Proposed Development of Employment Uses
Former Furtho Pits, Old Cosgrove Road, Old Stratford
Northamptonshire

LVIA Review

October, 2025

Figure 2.1: Landscape Character Area Plan

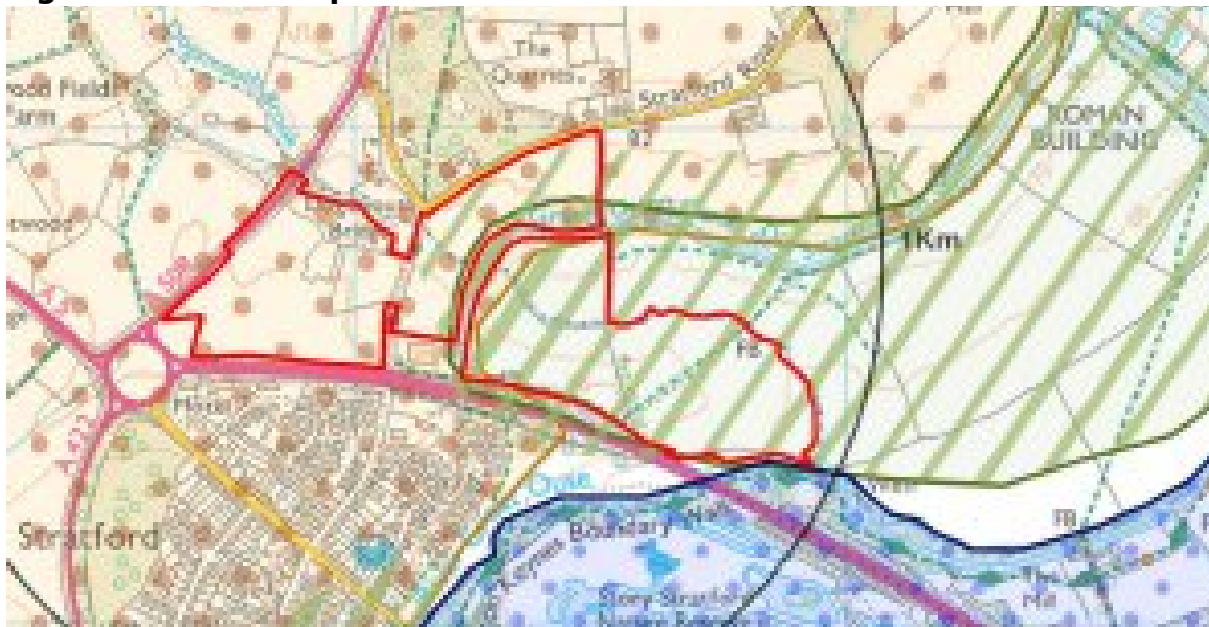
- 2.2 The nomenclature of these LCTs/LCAs can be misleading. As mentioned previously, the site is located within the valley of the Dogsmouth Brook, and therefore does not form part of the Tove catchment. The floodplain in which the eastern part of the site is located relates to the Dogsmouth Brook and the adjoining River Great Ouse, not the River Tove.
- 2.3 The site occupies a transitional location where the valley of the Dogsmouth Brook widens as it flows south-eastwards from the locally-elevated Undulating Claylands, before merging with the floodplain of the Great Ouse. Reflecting this, the LVIA divides the character of the site roughly into two halves, with the western and central parcels (where built development is proposed) forming part of the valley

- 5.19 The categorisation of the adjoining section of the Great Ouse Valley as an Urban River Valley (ref **Figure 2.1**) should not be misunderstood. It is urban because of its proximity to built-up areas and sources of visual and acoustic impact such as the A5, i.e. because of its setting – not because of its intrinsic character.
